- DESIGN CHANGES
1. Modular end links re-positioned slightly off existing buildings, with the party wall straightened and porch projections aligned with this wall, to ensure modular construction can be achieved off site.

| Project        | COUNTY FLATS, SANDFIELDS   |
| Title          | BLOCK 03/04 ELEVATIONS 1/2 |
| Drawing number | A013                       |

01 E01 - Bevin Avenue Elevation  
1 : 100

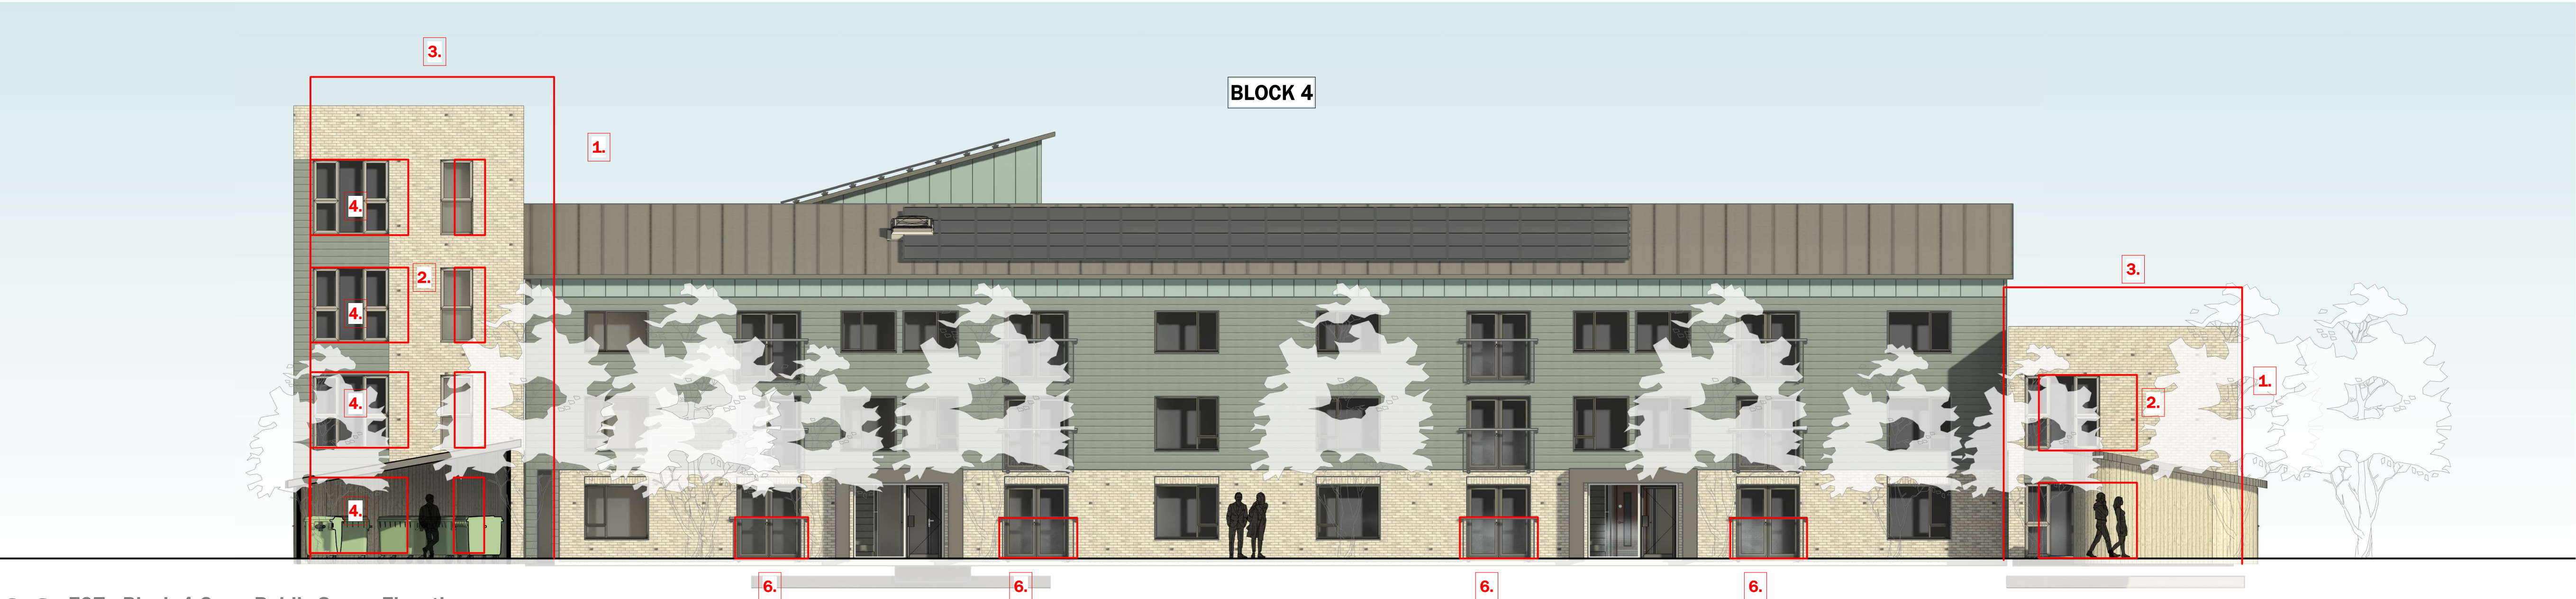
2. Windows have been slightly re-positioned to the new build to suit the structural design of the modular units and the constraints of the timber frame.

3. Parapet to modular end blocks have been lowered by approx 900mm to comply with the structural wind loadings and timber frame design.
  4. Corner windows have been removed and replaced with 2no. Windows on either corner, again due to the structural and timber frame design of the blocks.

5. PV panels have been omitted from the end modular units to suit the structural and timber frame design of the blocks.
  6. Ground floor Juliet balcony added to existing flats to provide better security whilst ensuring the open areas remain as communal spaces.

7. Air source heat pump external louvre enclosure amended to be single storey over entrance canopy to end link blocks.
  8. External air source louvered enclosure handed to provide internal riser/access requirements for maintenance.

9. Buggy/cycle store added to block 6 and 7 parking courtyards.
  10. Bin stores slightly re-positioned to suit existing drainage runs, with bin store near block 6 amended in size to suit located of bedroom window.

11. Footpaths amended to be Tarmac.
  12. Windows in communal area to the linked blocks made narrower to ensure 1.8m fire separation distance to existing windows is achieved to comply with building regulations.

13. 1no. window in block 7 communal area either side of stairwell removed to ensure 1.8m fire separation distance to existing windows is achieved to comply with building regulations.
